Our ref: L.A11309.003.West_Yamba.docx

RE: WEST YAMBA FLOOD MODELLING

Response to Peer Review

Figure:
B-6

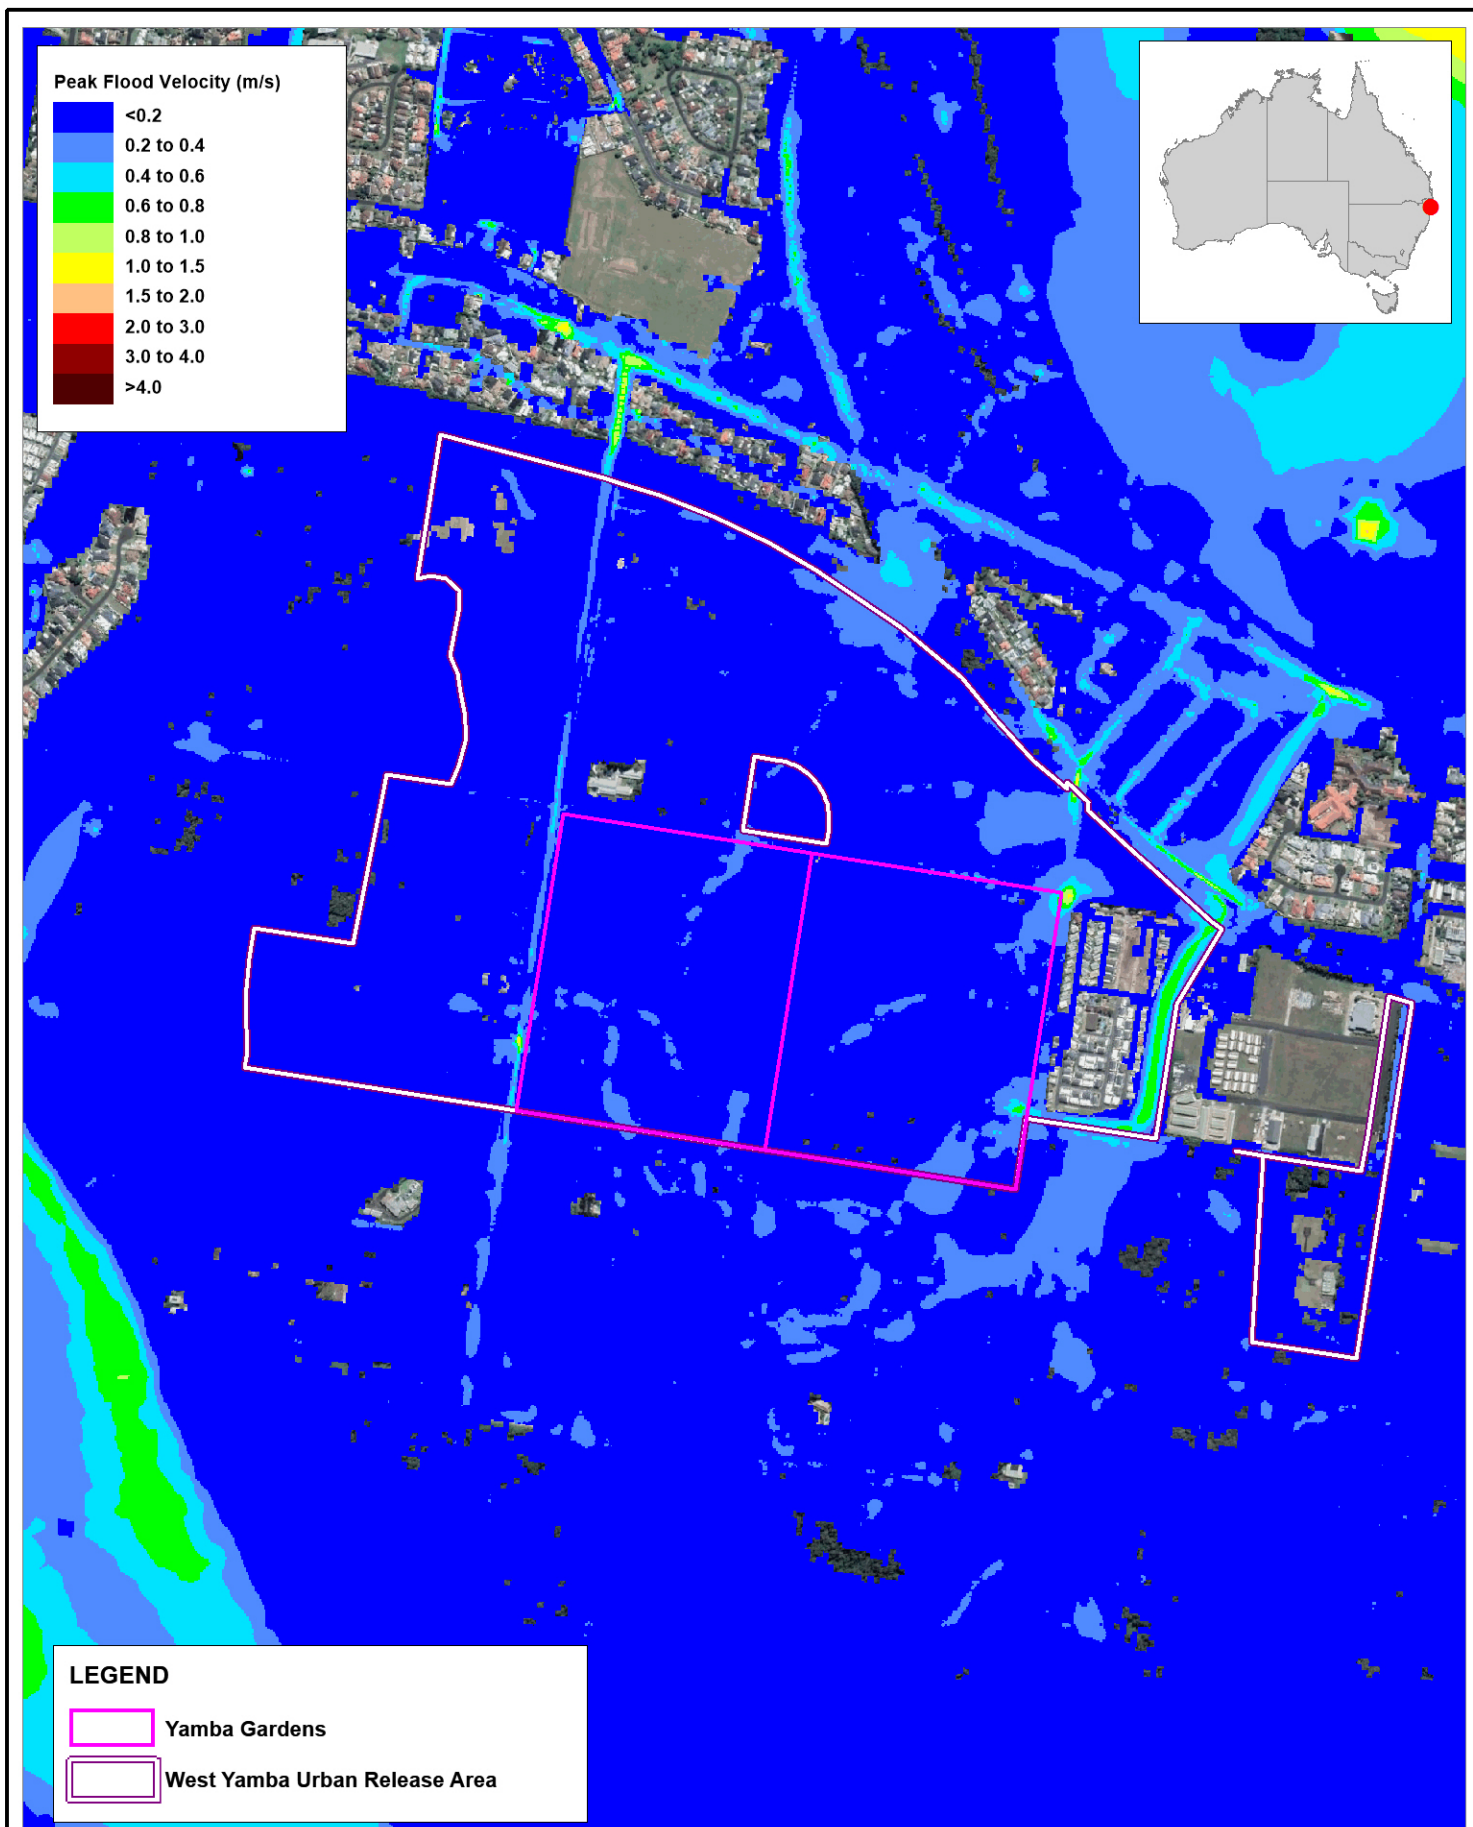
The review also recommends that other impact variables should be assessed including potential changes to velocity and time of inundation.

As noted by WMAwater, there are some increases in peak velocity on Carrs Drive within the WYURA, for example in the 1 in 100 AEP under Option 2 (see Map B-6). However, there is a decrease in flood hazard along Carrs Drive at the same locations showing these velocity increases (see map C-6). This is due to the increased height of Carrs Drive as part of the development resulting in lower flood depths. The flood hazard (which is a function of both depth and velocity) shows an overall reduction.
